# North Hertfordshire District Council

## Building Conservation comments

**File Ref:** 24/02424/FPH & 24/02425/LBC

**Address:** 72 Tilehouse Street, Hitchin, Hertfordshire, SG5 2DY

**HET 1614/01 Rev A**  
**20/01231/FPH & 20/01232/LBC**

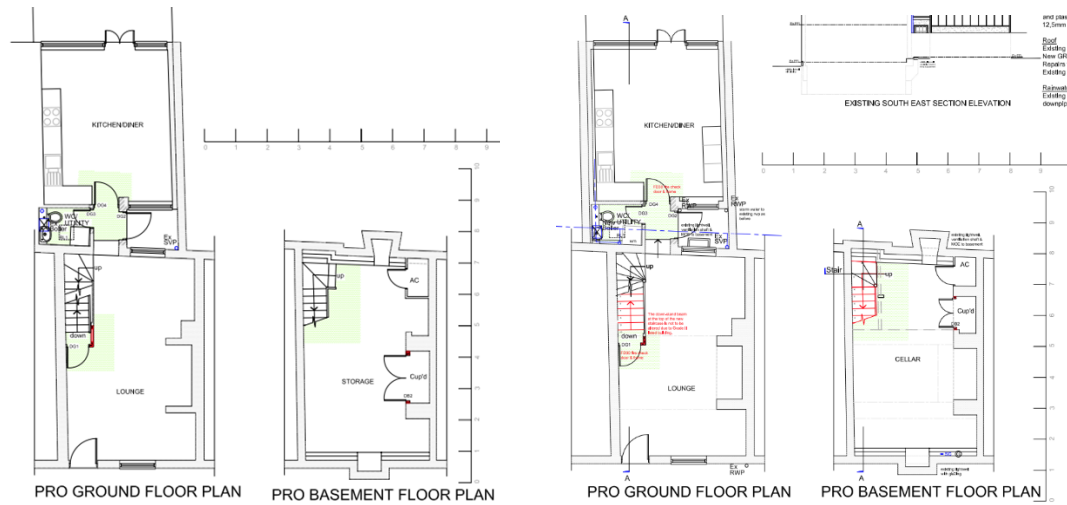
2. Notwithstanding approved drawing no. HET 1614/10 Rev A, the down-stand beam in the basement in the vicinity of the top of the new basement staircase shall not be altered unless otherwise agreed and approved in writing by the Local Planning Authority.

**HET 1614/11 Rev A**

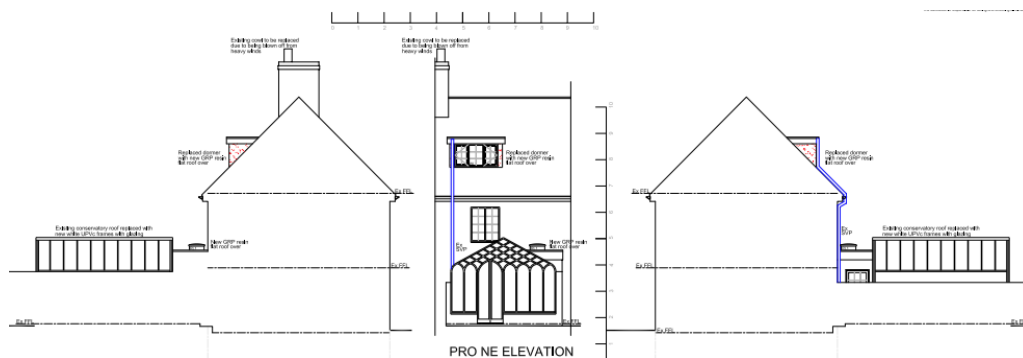
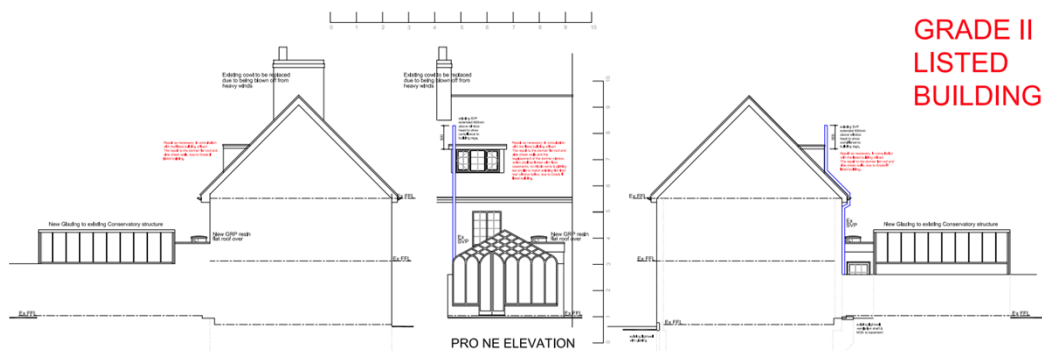
3. Notwithstanding approved drawing no. HET 1614/11 Rev A, the new windows to the replacement dormer shall be manufactured in timber with flush casements and no trickle vents and the glazing bar profile shall match as closely as possible that of the glazing bars to the first floor window on the rear elevation unless otherwise agreed and approved in writing by the Local Planning Authority.
